Addendum 03

Regarding: **Logan Place SRO Apartment – Bidding Documents**

Subject: **Addendum 03**

SKA-1

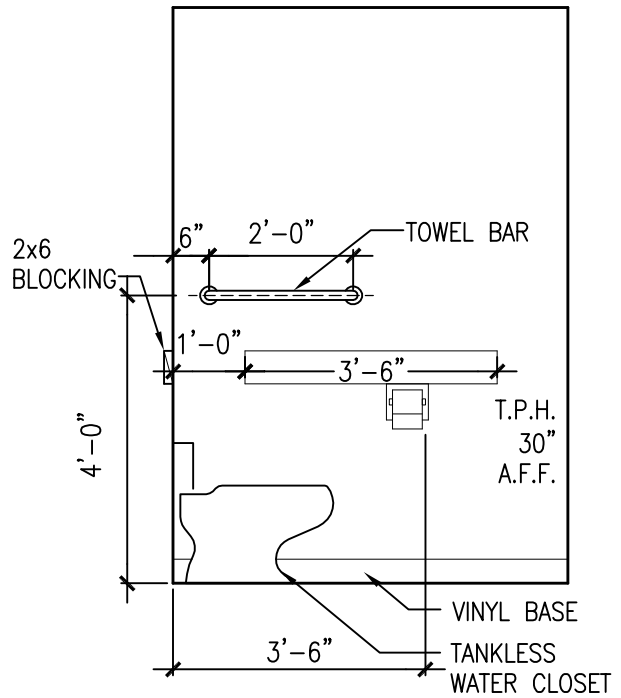
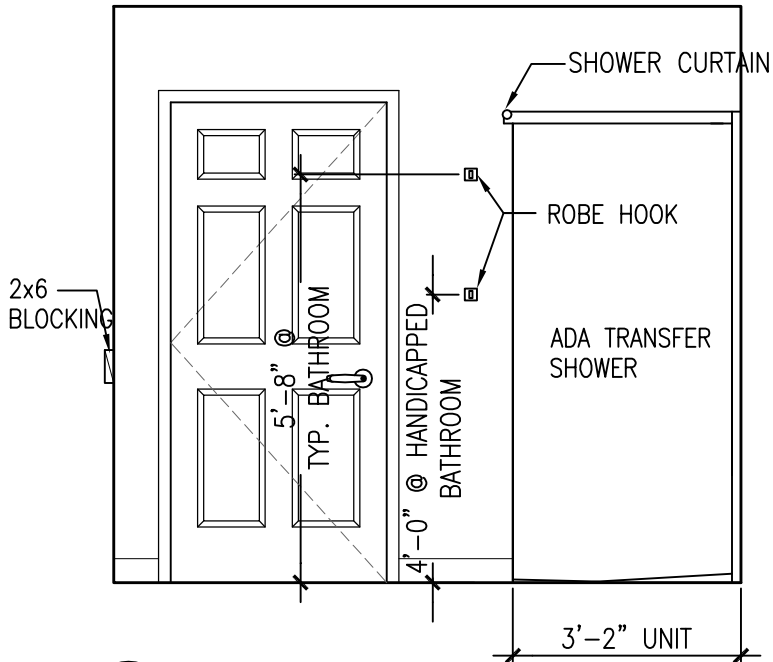
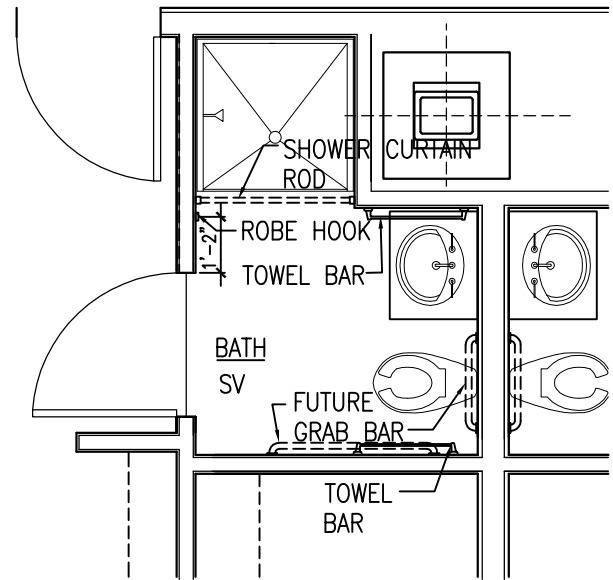
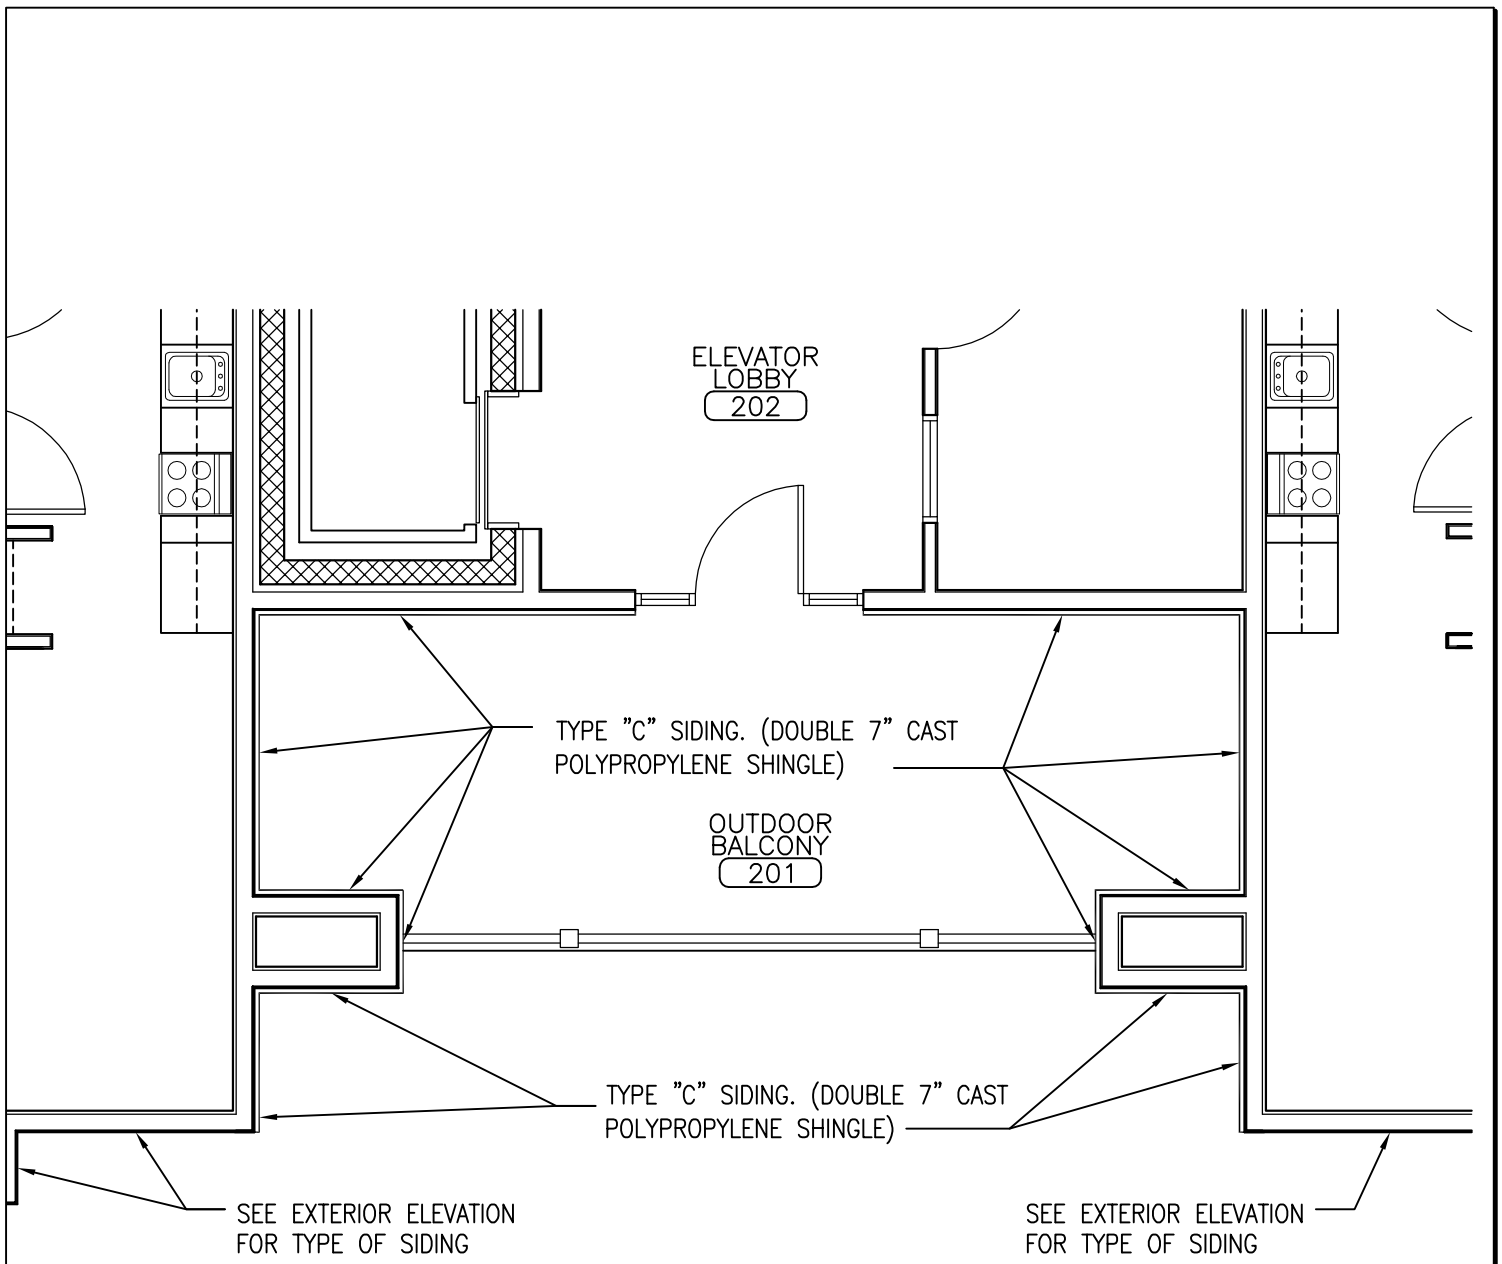
14. See attached SKA-1 for Towel Bars and Robe Hook location in all unit Bathrooms.
15. Provide Roll-Up shades and Curtain Rods to all SRO unit windows except Unit # 128 and #129. Provide mini binds and Curtain Rods at windows in Unit # 128 and #129. Provide mini binds only at all other windows except where located in Stair #1 [109] and Stair #2 [102].

POLE BASE DETAIL
 SCALE: NONE

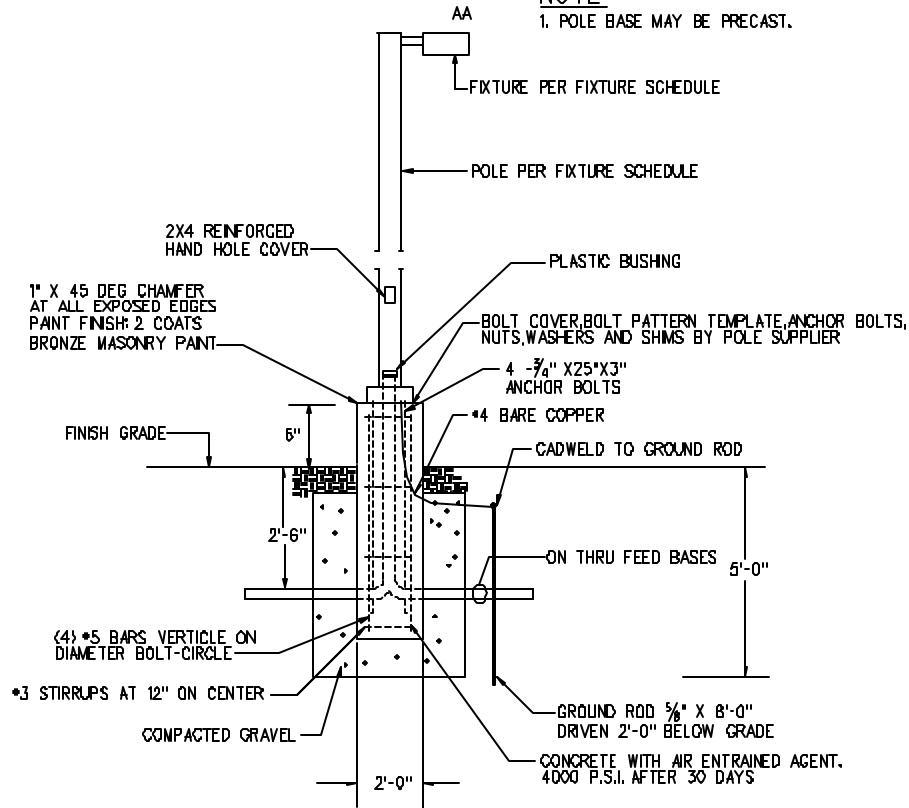
22. See attached SKE-1 for fixture type AA description and pole base detail.

Title: **ON-SITE WORK LIMITS
LOGAN PLACE-PHASE 1**

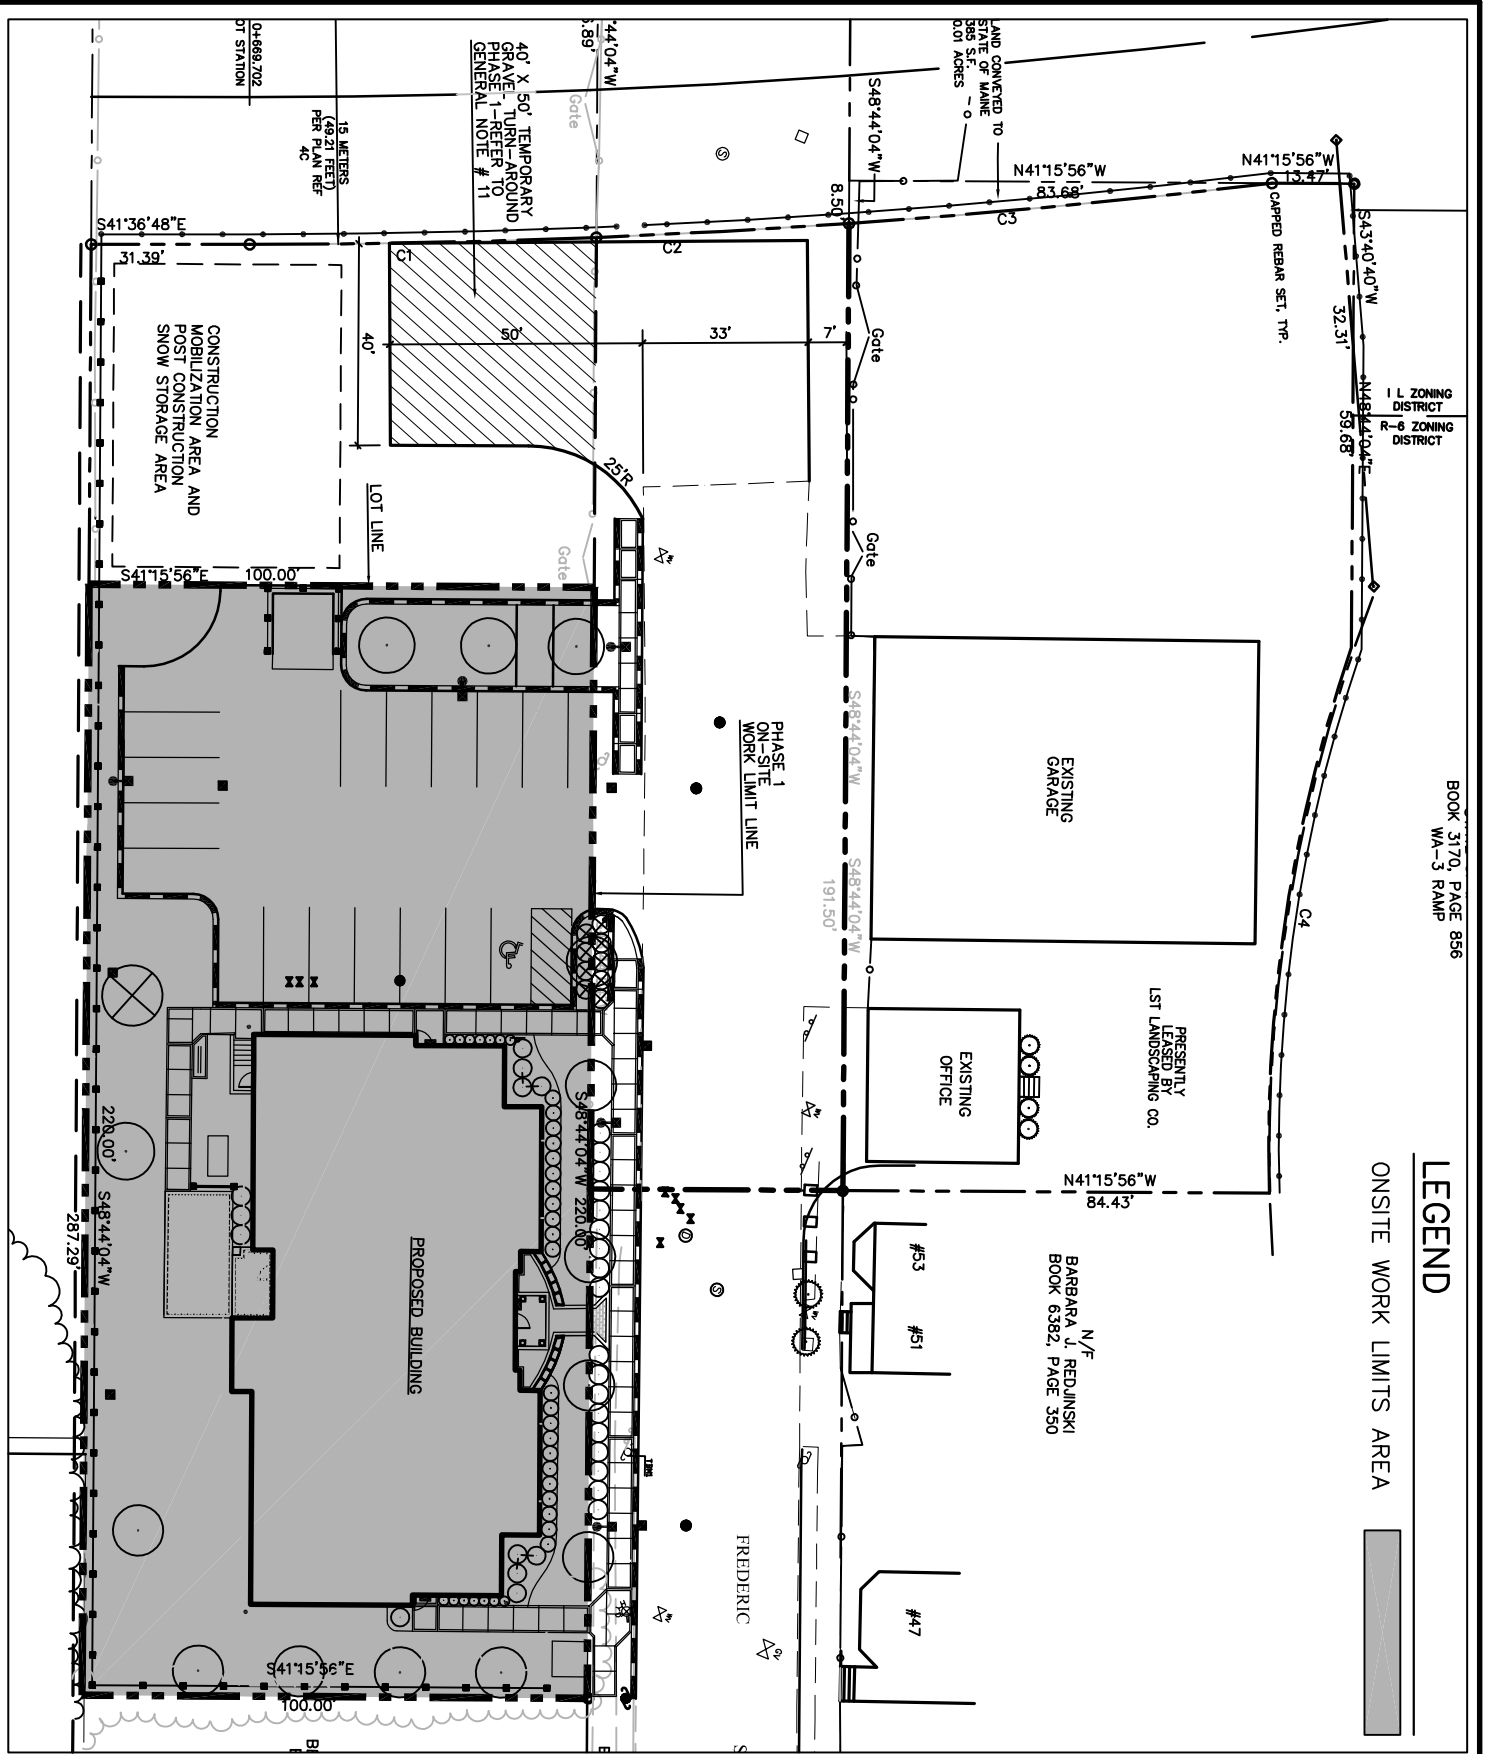
4. See attached sketch title "On-Site Work Limits, Logan Place Phase I" by Mitchell & Associates dated 25JAN04 for a delineation of such.
